**CRAIG CROTTY
ARBOR CULTURE LLC**

RE: Observations and comments regarding trees located at 824 S. Gladys Avenue

ARBORIST STATEMENT

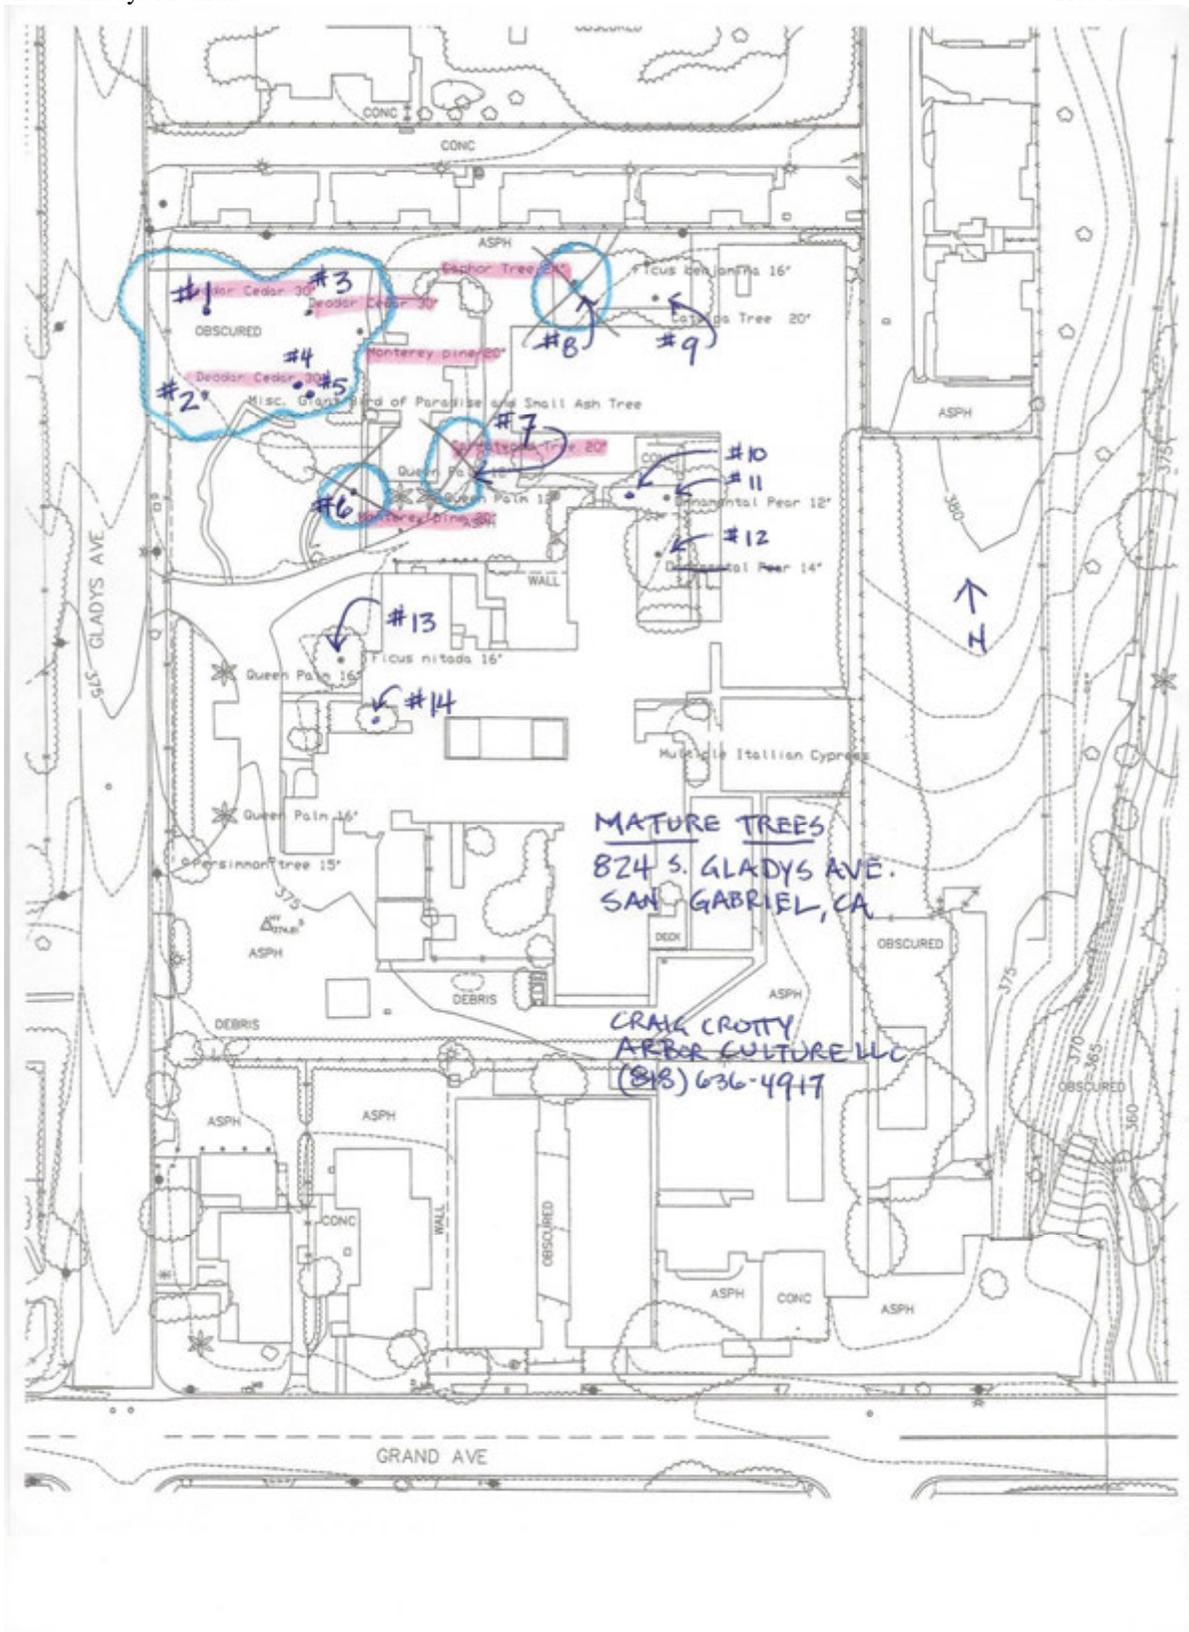
There is a planned perimeter roadway around the new complex. A paved road currently exists along the north side of the site near Cedars #1 and #3. At this point it is unclear exactly how wide the new road will be required by the Fire Department. These are large trees, to protect the roots zone the best case recommended distance to hold back pavement would be:

- #1 Cedar-36 inches dia.-hold back pavement 15 feet.
- #3 Cedar-34 inches dia.-hold back pavement 14 feet.

If these distances are not possible due to fire mandates, we may need to look at alternative pavements within the protection zones. This might include paving stones meandered around the trees on less compacted than usually required base material. Soil compaction reduces permeability and kills absorbing roots as one of the primary killers of trees on construction sites.

- Cedar trees should be deep watered within their driplines but not on the base of the trunk. Hold back irrigation water eight feet minimum from tree trunks. Begin maintenance watering as soon as possible.
- Crown cleaning pruning to remove dead, dying, and broken branches is needed.
